UNITED STATES PATENT AND TRADEMARK OFFICE

Office Action Summary	Application No. 10/049,834	Applicant(s) SCHEIBE ET AL.	
	Examiner Jason J. Boeckmann	Art Unit 3752

DETAILED ACTION

Examiner's Marked Up Figure #3

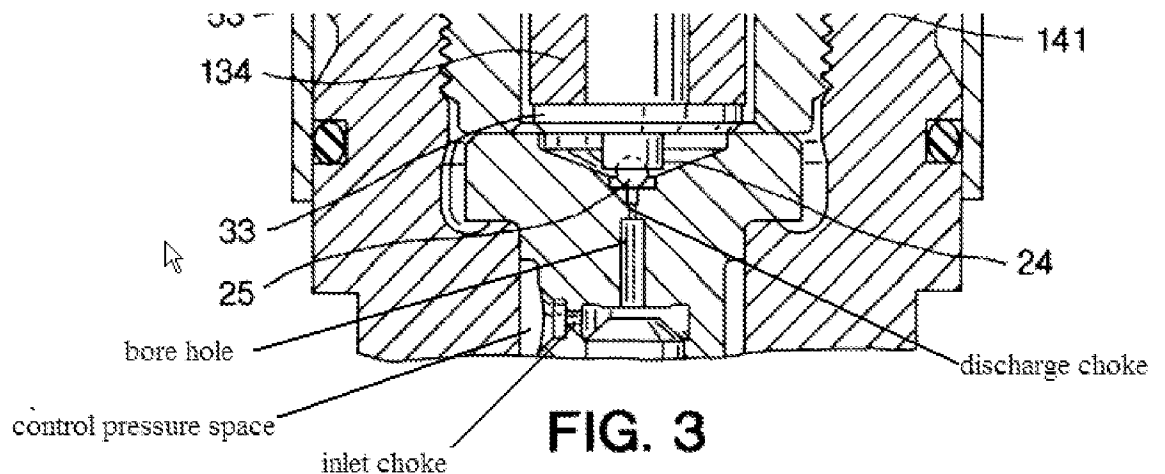
Regarding claims 2 and 22, the stop surface of the actuator is significantly larger than the sealing surface (see Fig. 3).

Regarding claims 5 and 25, the valve body is constructed as a sphere, which interacts with the opening for the passage of fluid, forming a seal (See Fig. 3).

Regarding claims 7, 9, the valve actuator (139) is essentially mushroom-shaped, the stem of the mushroom forming the valve rod and the stop surface of the actuator being an annular collar, concentrically surrounding the valve rod in the region of the mushroom cap (24) (see Fig. 3).

Regarding claims 10, 11, 27 and 28, the valve rod is guided axially movably in at least one guide bushing (134) and is disposed at a small distance from the sealing surface of the actuator (see Fig. 3).

Regarding claims 12, 13, 29 and 30 the length of the valve rod is a multiple of its diameter (see Fig. 3) and the sealing surface is formed in the end face of a disk-shaped insert part (the valve seat) (see Fig. 3) and adjoins the control pressure space on the side averted from the sealing surface.

Regarding claims 14-19, and 31-36 the insert part (also forms a stop for the valve needle) is formed in two parts with a first part, which contains an opening for the passage fluid and a discharge or outlet choke (see examiners marked up figure 3) and a second part at the control pressure space side, with a bore hole (see examiners marked up figure 3) which connects the control pressure space (see examiners marked up figure 3) with an opening for the passage of fluid. The second part contains an inlet choke (see examiners marked up figure 3) near the bore hole (see examiners marked up figure 3). The pressure space is connected with an inlet choke and the rear end of the valve needle (see examiners marked up figure 3) averted from the nozzle needle seat surface lies in the control pressure space. The pressure insert part also including an inlet choke and an outlet or discharge choke (see figure below).
